NUMBER: 84-21

- A. MerCarb Acceleration "Bog" - MCM 120R/140R/470R/898R
- B. MerCarb Right Turn Lean Out - MCM 120R/140R
- C. MerCarb with No Adjustment on Idle Mixture Screw -
MCM 120R/140R/470R/170MR/898R/200MR

Figure 1. 3302-9046 Pump Kit

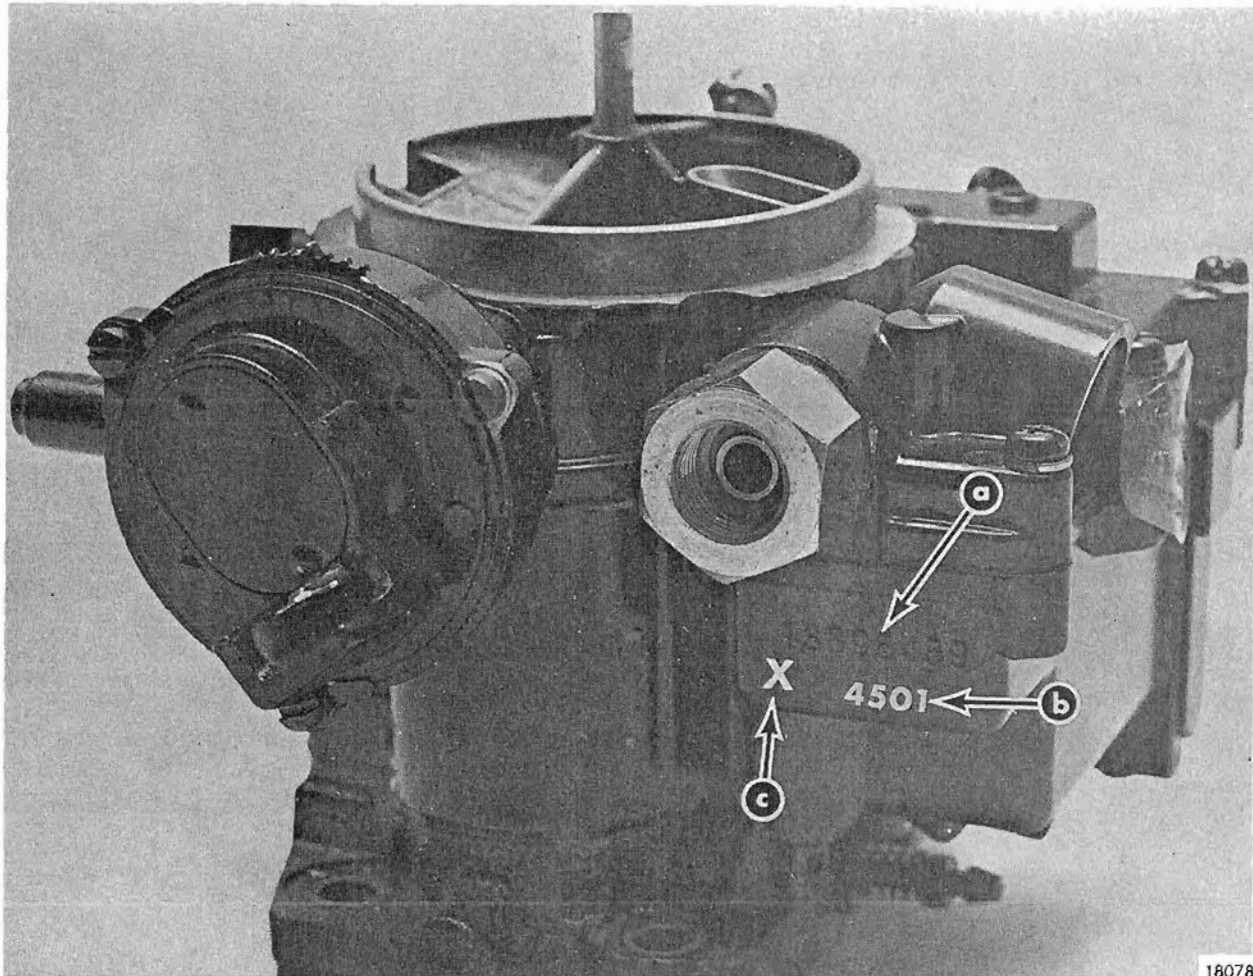
You may receive complaints that the above model engines "bog" on acceleration. We have found the problem to be the neoprene seal on the accelerator pump in the carburetor. The original seal will expand when subjected to gasoline containing alcohol. Many automotive regular leaded, non-leaded or premium gasolines sold today, contain alcohol, although it is not advertised as gasohol.

1. Replace accelerator pump with kit P/N 3302-9046. (Figure 1)

NOTE: All 3302-9046 kits shipped from Mercury Marine in the past have the new seal material.

Figure 2. Carburetor Identification

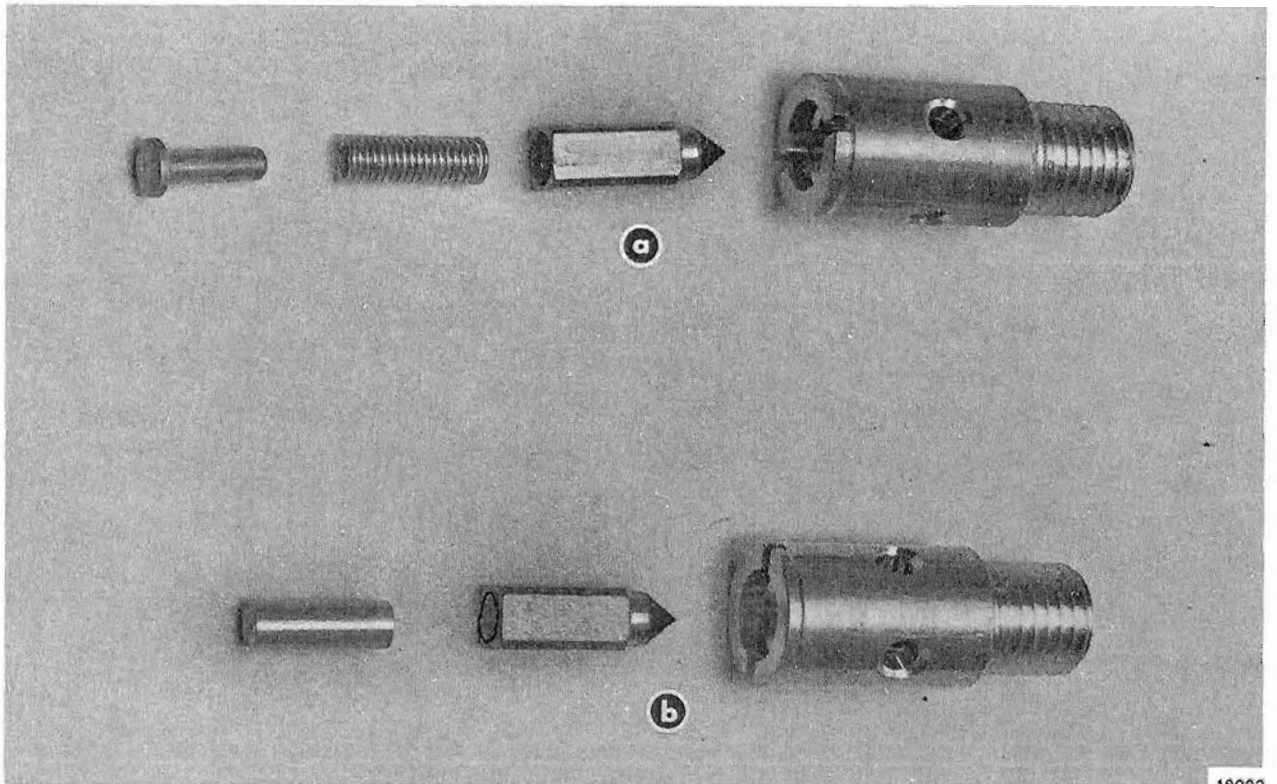
IMPORTANT: Carburetors with a date code of 4501 and above have the new kit already installed. (Figure 2)

2. As a temporary fix, stronger duration springs (only) were sent to dealers. On carburetors that had only the duration spring changed, a new 3302-9046 Pump Kit should be installed.
3. The screen (in the bottom of the accelerator pump hole) should be left in. If screen is dented downward, toward check ball, replace screen.
4. Check pump rod adjustment as outlined on page 20 of the MerCarb Service Manual SIS-864.
5. After installing new kit, make an X at location shown in Figure 2.
6. Start engine and check timing.

Figure 3. Difference Between Inlet Seat Kits

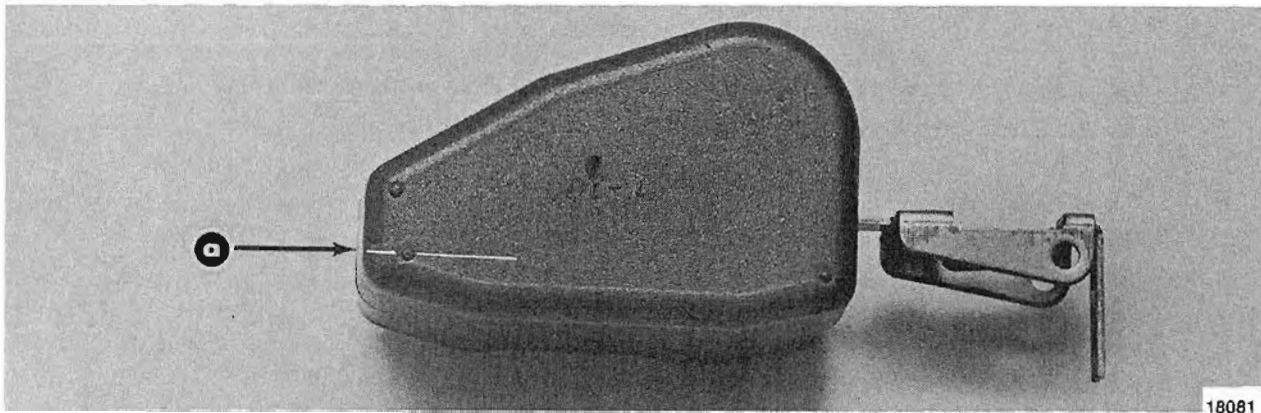
You may have a complaint about a right hand turn lean out. A good example would be, while pulling a water skier, the skier falls. The driver puts the boat in a hard right turn and accelerates to go back to the fallen skier. If the engine hesitates during this time, proceed as follows:

1. Replace original inlet seat kit with 3302-9407 Inlet Seat Kit. The original kit has a spring loaded needle while the new kit has a solid, two piece needle. (Figure 3)

IMPORTANT: Carburetors with a date code of 4801 and above have the new 3302-9407 Inlet Seat Kit installed. Date code location is shown in Figure 2.

Figure 4. Float Assembly

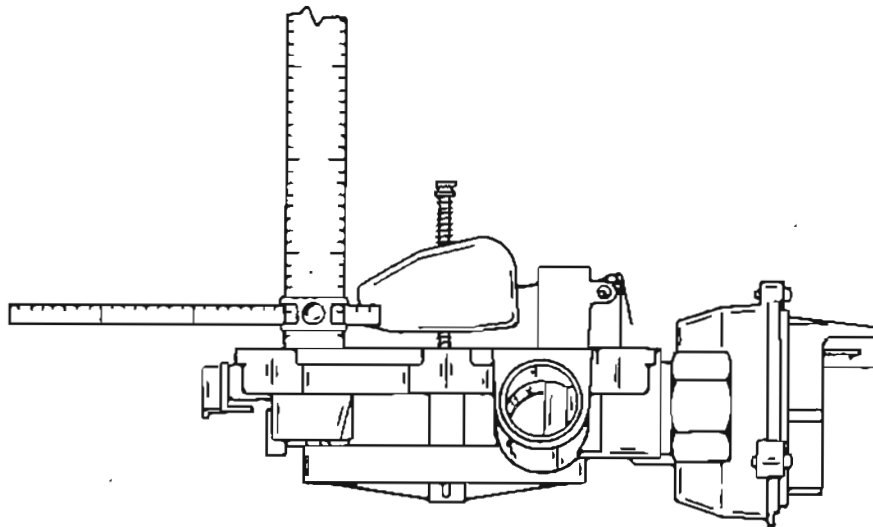
2. Reset float level to 5/16" (7.5mm) as shown in Figures 4 and 5. This float level is higher than original level.
3. DO NOT make mark on carburetor after this change has been made to it.
